**A RESOLUTION OF THE CITY COUNCIL OF SUNNYSIDE,
WASHINGTON, ADOPTING THE PLANNING COMMISSION'S
RECOMMENDATION AND APPROVING THE PRELIMINARY
PLAT OF COLUMBIA HEIGHTS PHASES 2 AND 3**

SUNNYSIDE PLANNING COMMISSION
RECOMMENDATION TO THE SUNNYSIDE CITY COUNCIL
PRELIMINARY PLAT OF
COLUMBIA HEIGHTS, PHASES 2 & 3
PLP-26-3, SEPA-26-3

**CITY OF SUNNYSIDE
PRELIMINARY LONG PLAT RECOMMENDATION**

DATE:	December 9, 2025
APPLICANT:	Moon General Construction, LLC c/o Jorge Herrera
FILE NUMBER:	PLP-25-3, SEPA-25-3
LOCATION:	Vicinity of Columbia Ave. and Lander Ct.
TAX PARCEL NUMBER(S):	221026-31608, 31535, 31535, and 31537
APPLICATION DATE:	July 9, 2025
DATE OF COMPLETENESS:	September 17, 2025
RECOMMENDATION:	APPROVE WITH CONDITIONS

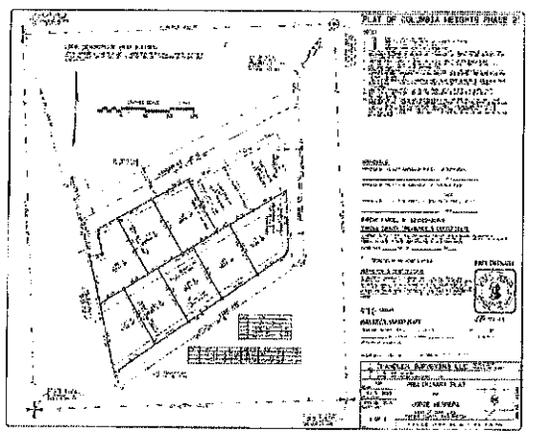
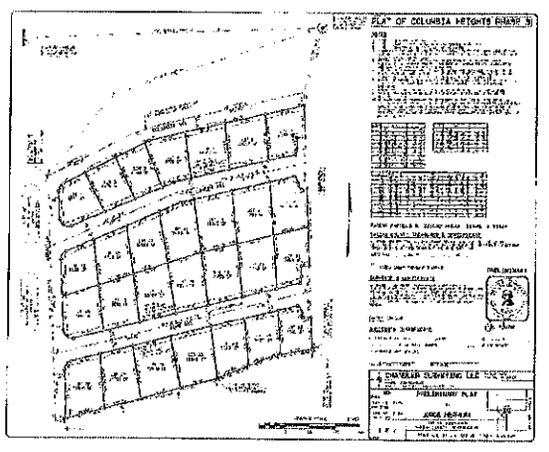
Phase 2: All proposed lots in Phase 2 have direct access to and frontage upon a dedicated public street. Phase 2 proposes access to Lander Ct. for Lots 1-3, which was partially completed as part of Columbia Heights Phase 1. Lots 4-8 are proposed to be accessed from Vine Ave. which will be dedicated as part of Phase 2.

Phase 3: All proposed lots in Phase 3 have direct access to and frontage upon a dedicated public street. Seven of the 28 lots in Phase 3 are proposed to be double frontage. Lots 1-7 will have frontage on Columbia Ave and Lander Ave; however, access will only be permitted from Lander Ave. This layout is consistent with Columbia Heights Phase 1 which included 5-lots having frontage on both streets, with access only coming from Lander Ave. This configuration is necessary due to the proposed layout and topography of the site. Portions of the Columbia Ave frontage include a steep north-to-south grade which lends itself to the proposed east/west streets (Lander Ave and Vine Ave) as opposed to new streets running perpendicular to Columbia Ave.

Staff Findings: The applicant shall provide full civil plans for street improvements. Phase 3 does propose two dead-end streets in excess of 500-feet with Hammer Head turnarounds on Lander Ave and Vine Ave. The terminus of the dead-end streets is adjacent to a vacant parcel (221026-31460) and a potentially developable parcel (221026-31508). While no plans have been submitted to subdivide or otherwise develop either parcel, the street layout of Phase 3 could be utilized for further extension if those parcels are ever developed in the future.

The dead ended water mains as shown in the civil engineering plans are required to be looped, consequently additional easements will be required. The Hammer Head turnarounds will be further reviewed during engineering permitting and if found to be deficient and not in the best interest of the fire department, then they shall be replaced with cul-de-sacs turnarounds.

3. All streets shall meet International Fire Code (IFC) grade requirements - IFC Appendix D, Section D103.
4. Access – All lots shall be accessed through internal streets. No direct access to Columbia Ave. shall be allowed for double frontage lots in Phase 3.

- a. A Note shall be added to the face of the Phase 3 Final Plat: "No direct access shall be permitted to Columbia Ave."
5. All stormwater shall be retained on-site. The applicant shall submit plans for city approval, consistent with the Department of Ecology Stormwater Management Manual for Eastern WA.
